**Skilled Nursing Care / Mental Health Unit /
HIV – AIDS Unit and Renovation of Related
Support Facilities for
ELAYN HUNT CORRECTIONAL CENTER
LA State Project No. 08-413-97B-1, Part 7**

Addendum No. Three

ADDENDUM INFORMATION CIVIL
ELAYN HUNT SKILLED NURSING FACILITY
State Project No. 08-413-97B-1, Part 7
F&T Job No. 84637

PROJECT NO. 04021 / 520424 SHEET NO. **A1.03**

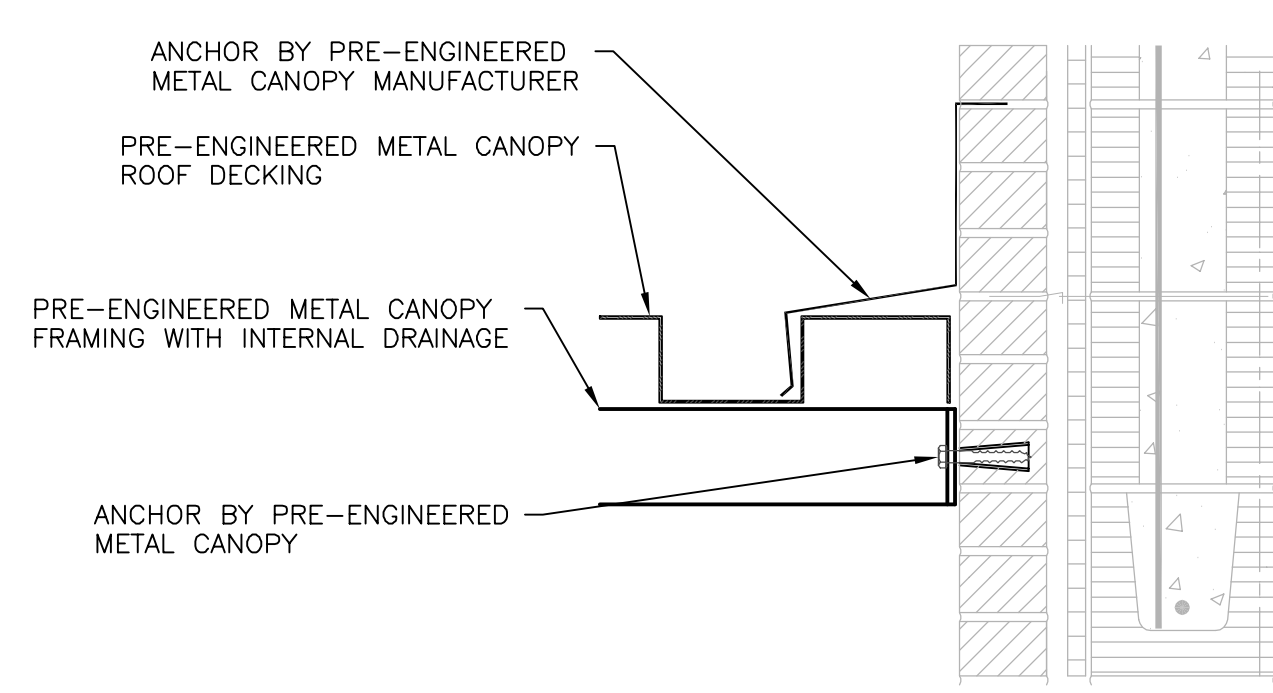
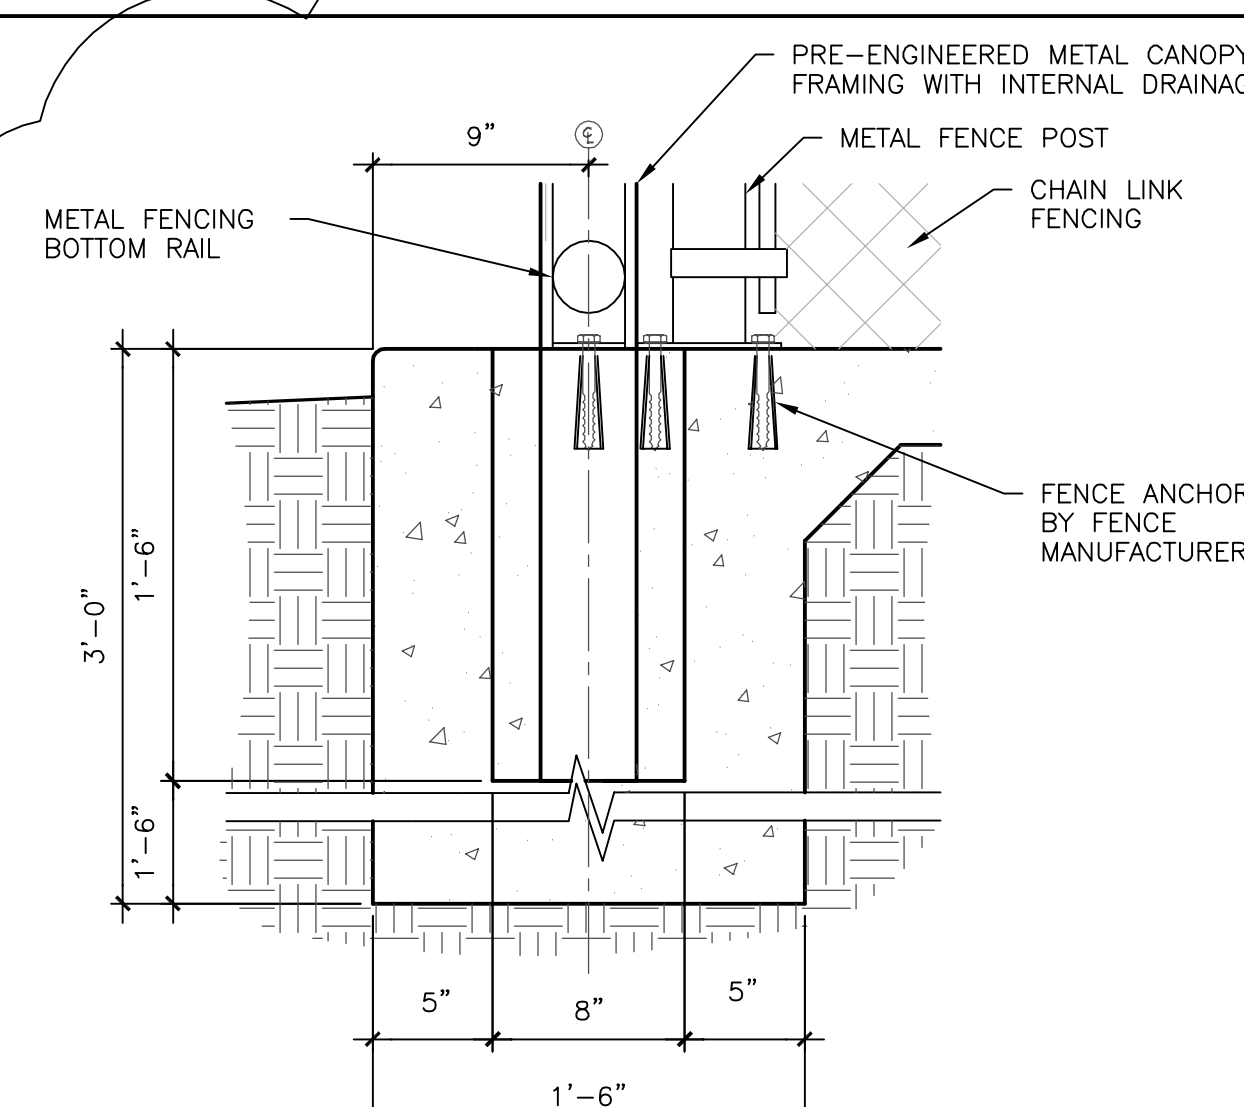
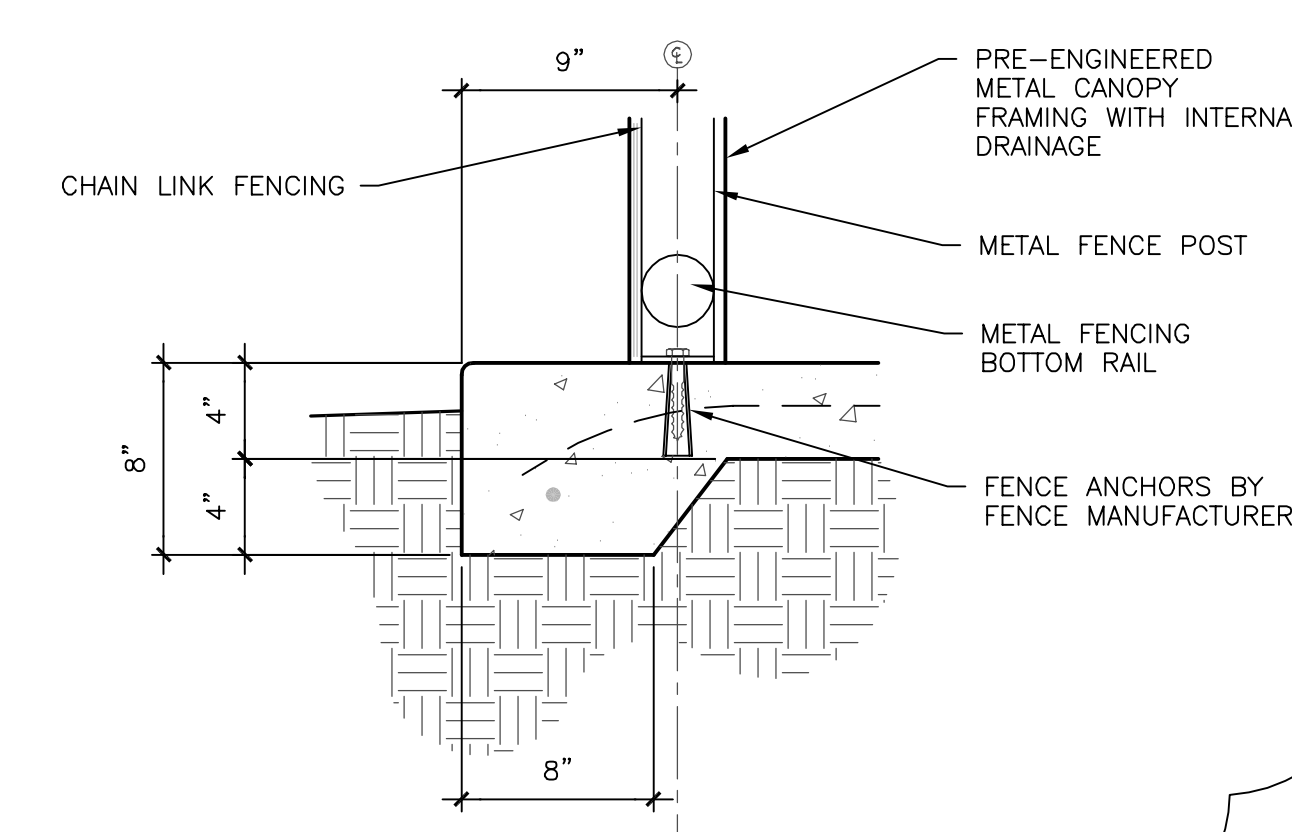
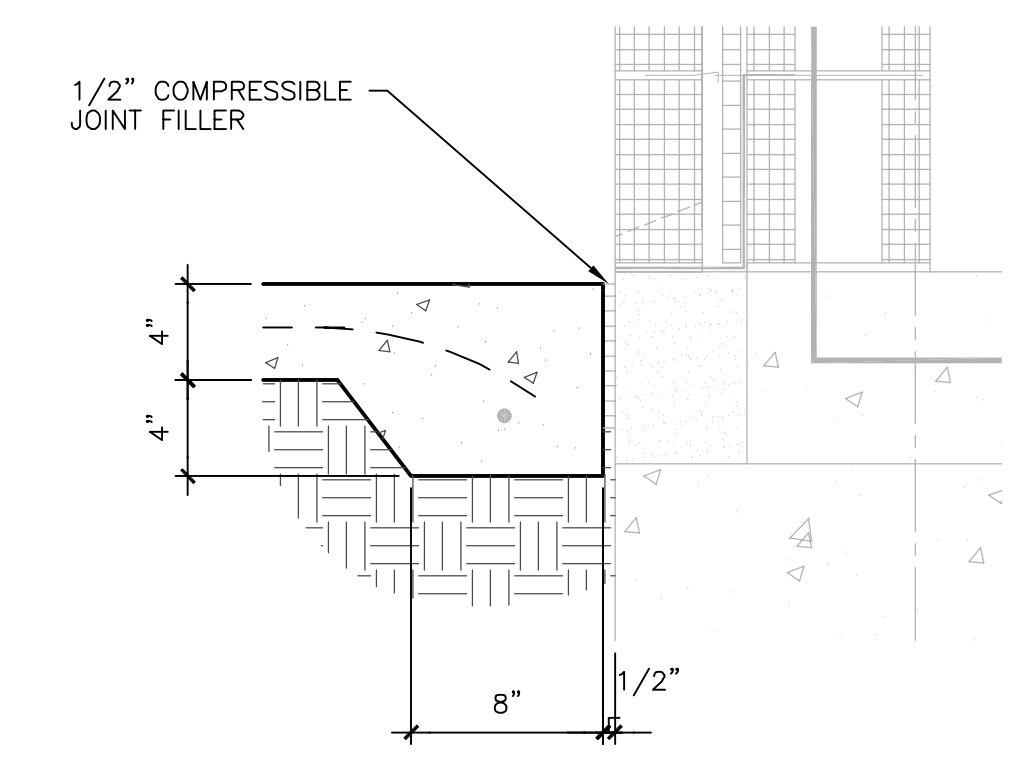
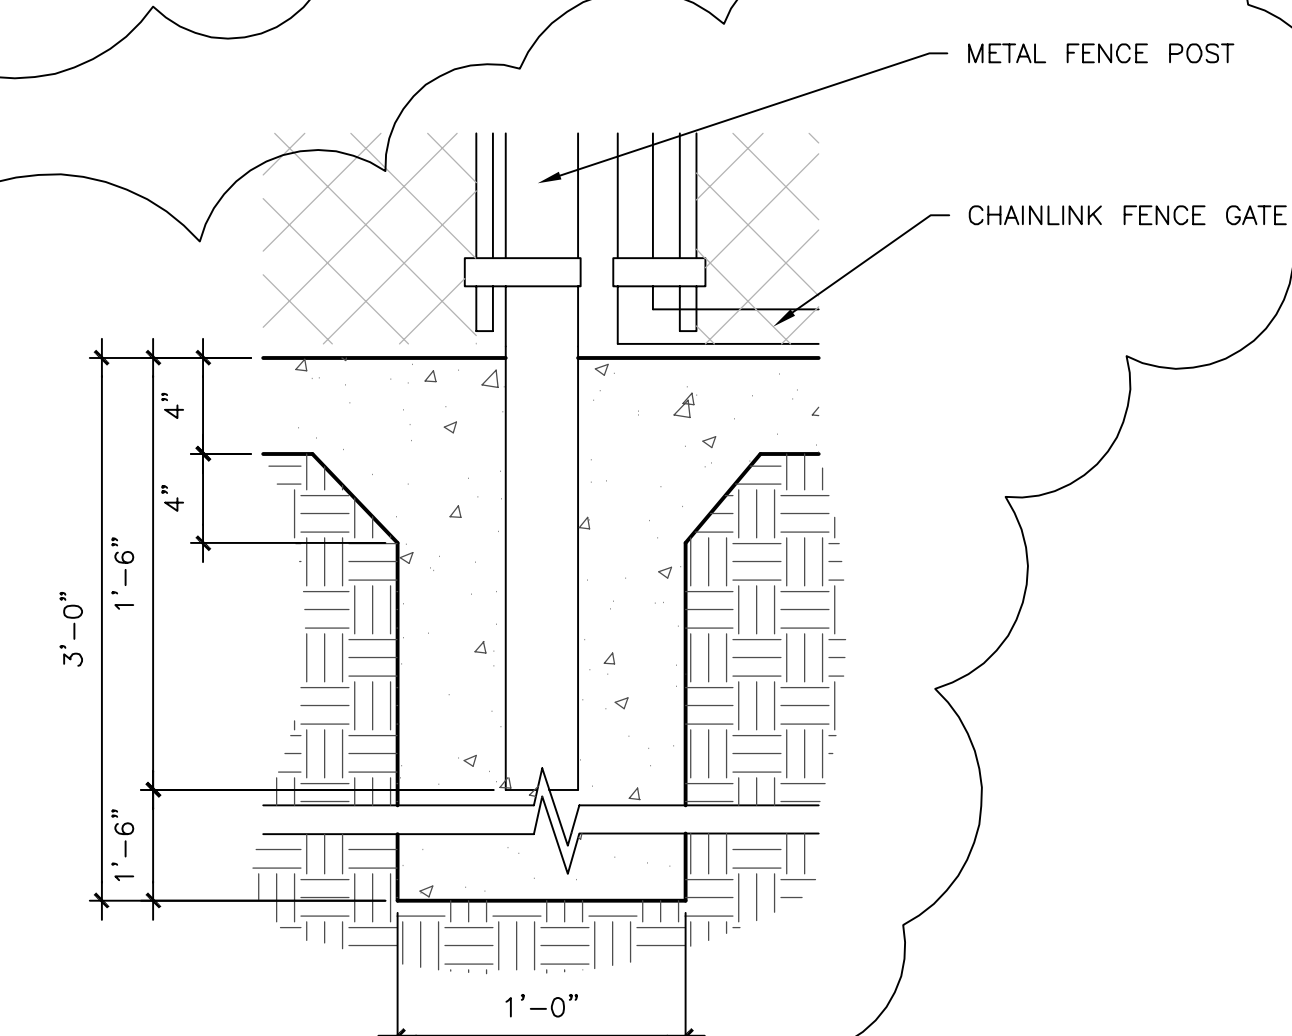
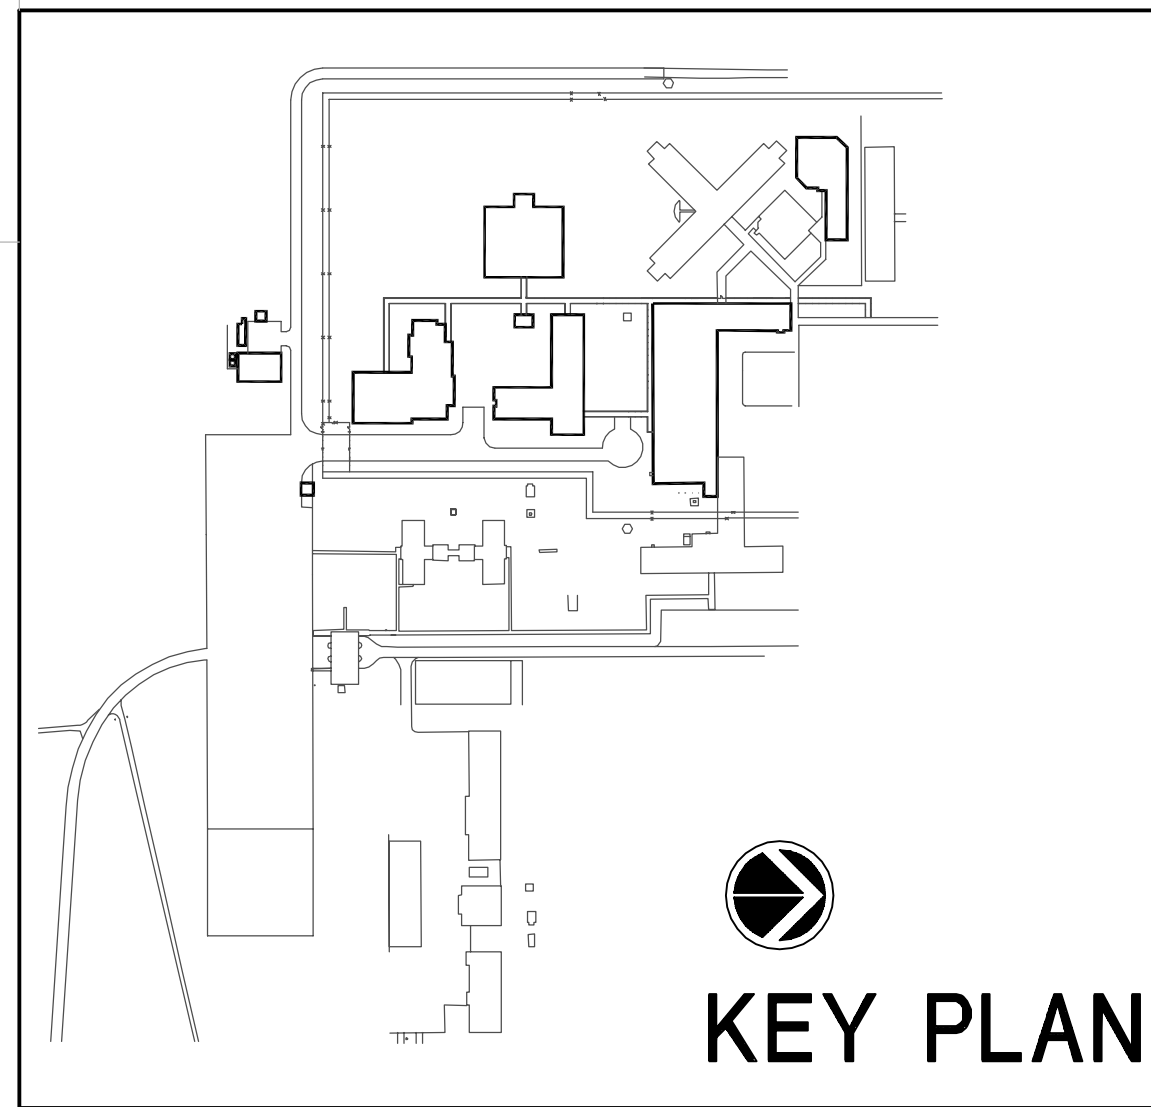
- 2) The thickness of the concrete canopy slab is 4". See attached revised A1.03 for dimension/scale clarification.
- 3) The concrete slab at the fence is a walkway 12'-0" wide as indicated on 11A1.03. See attached for clarification. The perimeter fencing is 12'-0" as indicated on 1A1.01 and referenced on A1.00. See attached for clarification.

- 13) Regarding Specification Section 04200-2.1-C-4a, split-faced blocks shall have scored joints as indicated on drawings.
- 14) The post size required at the canopy fence is 4"x4".

9 CONDUIT COVER DETAIL
SCALE: 3" = 1'-0"

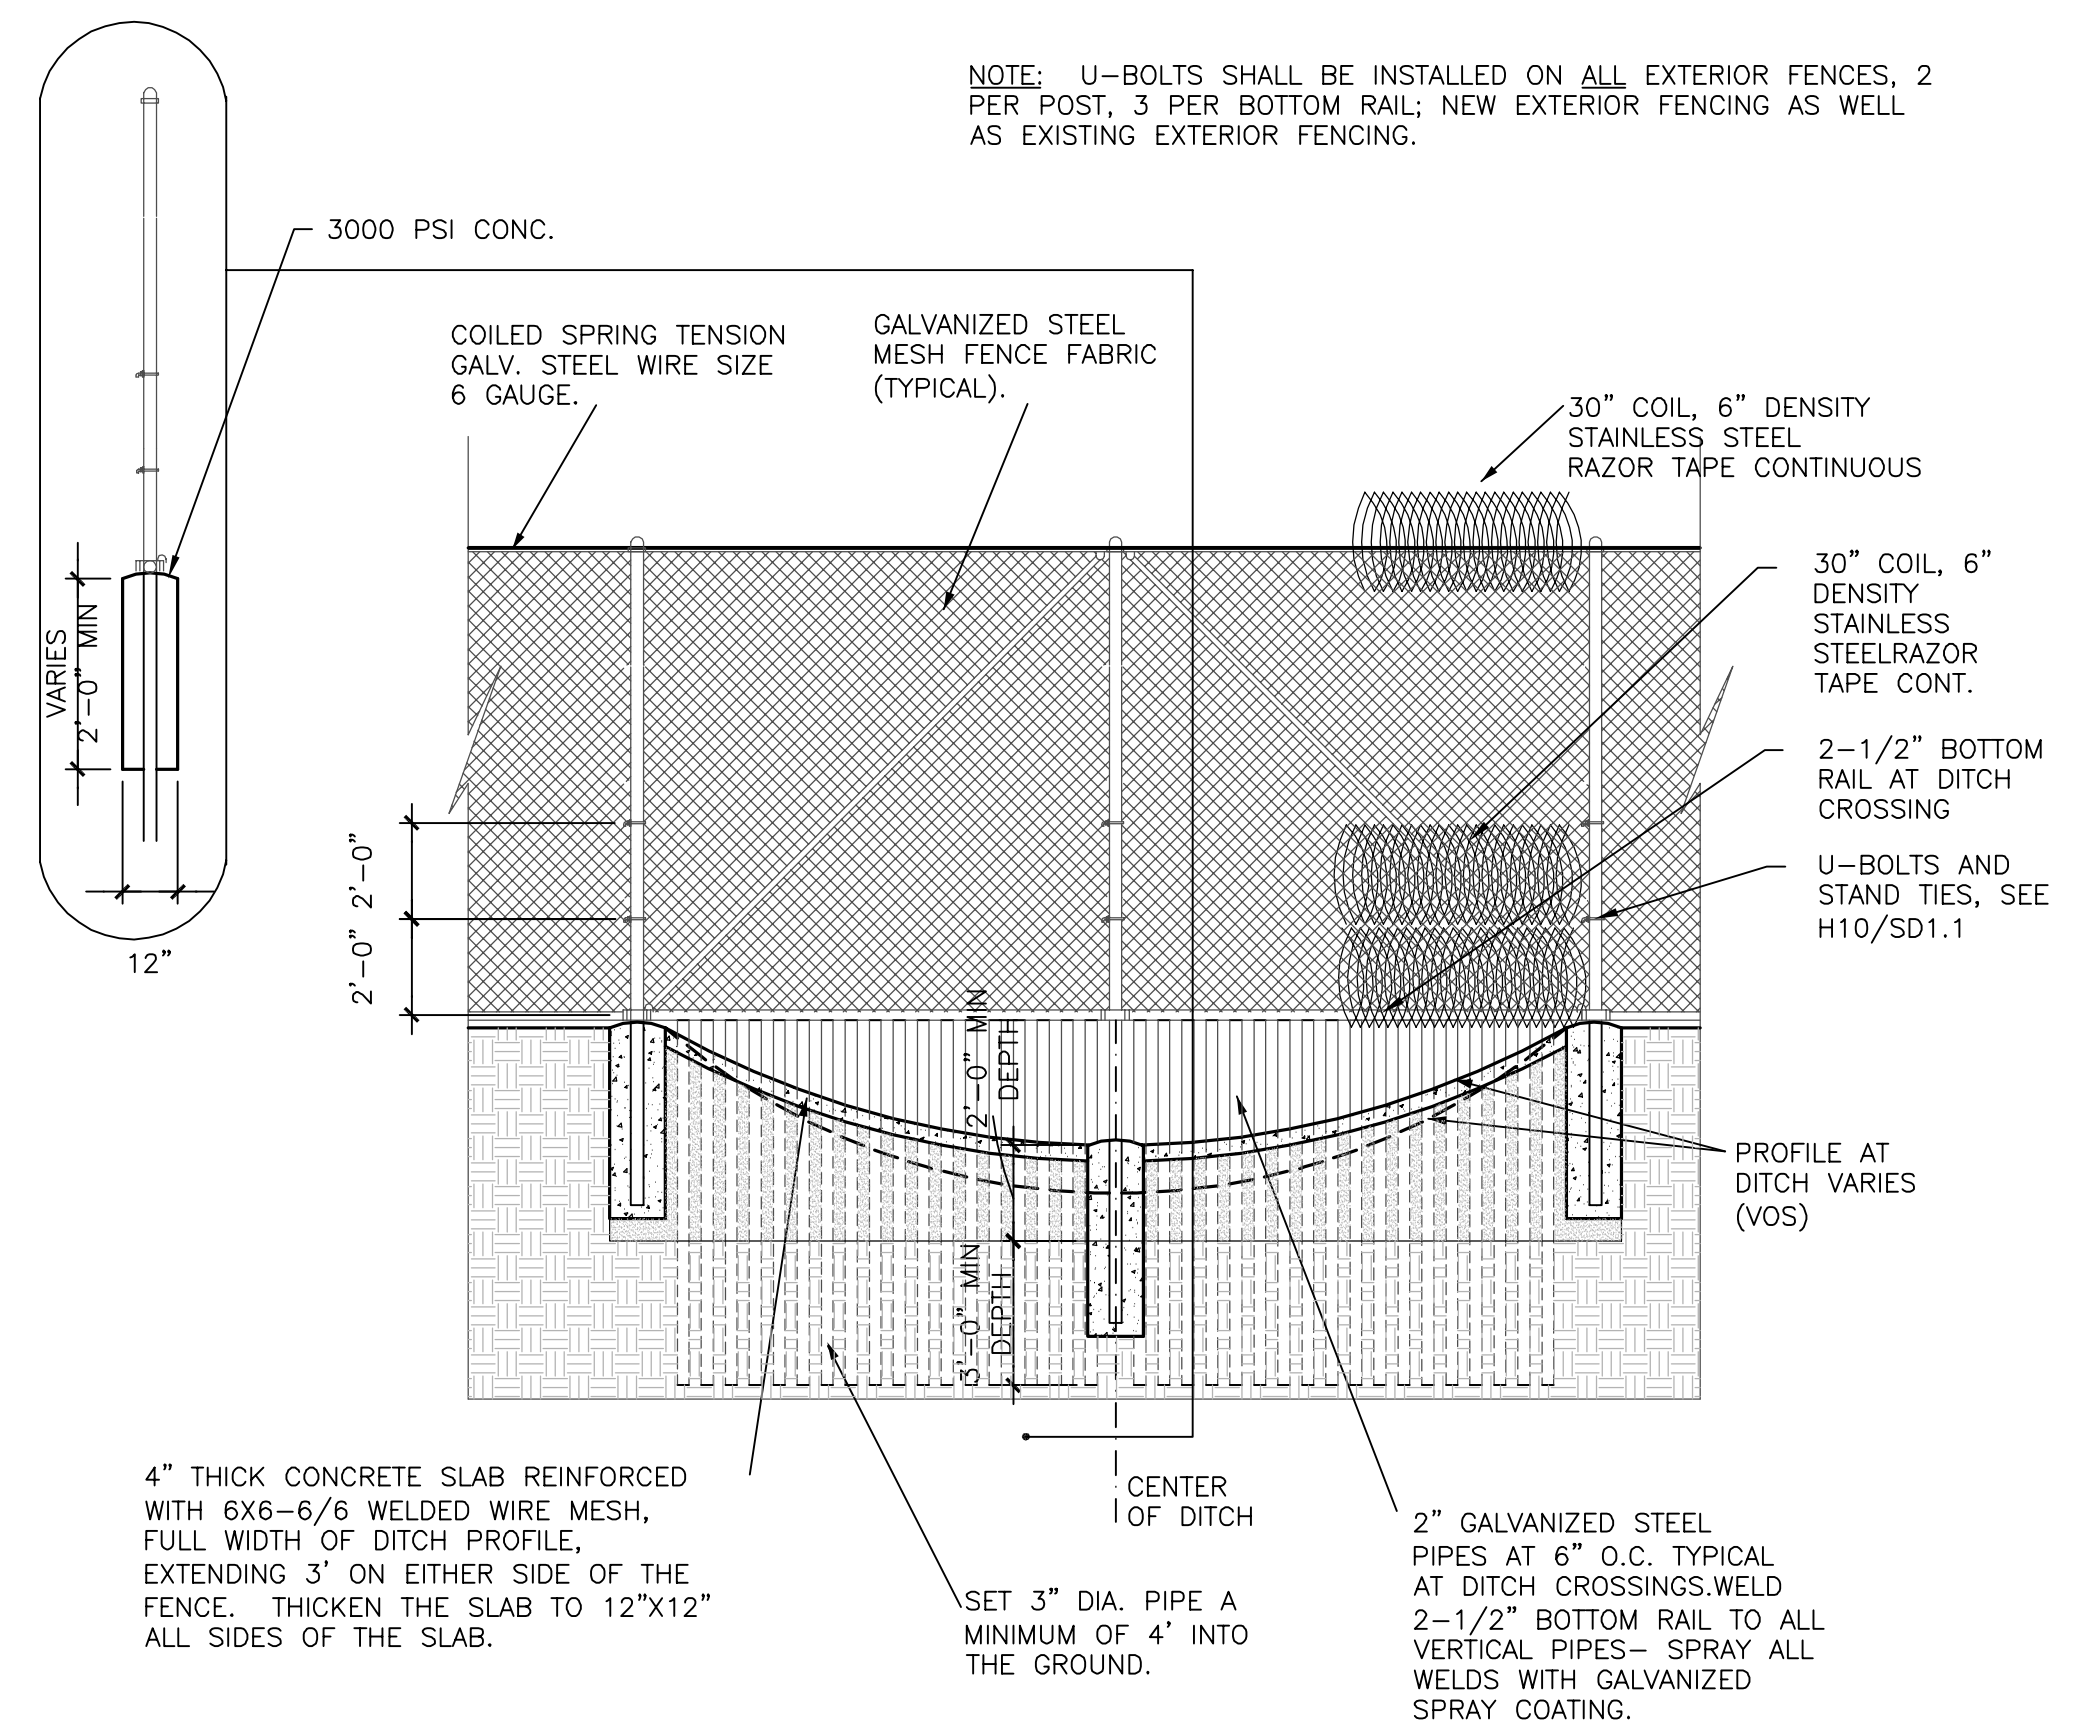
DRAWING A1.03, DETAIL NUMBER 9;

As a clarification, the walkway cover manufacturer shall provide a minimum 10gauge aluminum adapter shaped to fit the underside of the walkway cover profile and be sealed to the walkway to prevent entrance of contraband material and bird nesting. Adapter shall be coordinated and sized to match the walkway lighting fixture type (nominal 12" x 12") provided this project plus a minimum 1/4" extra width on each side. Walkway cover shall allow for field cutting of the conduit openings needed for installation of the walkway lighting system while still providing a watertight raceway.
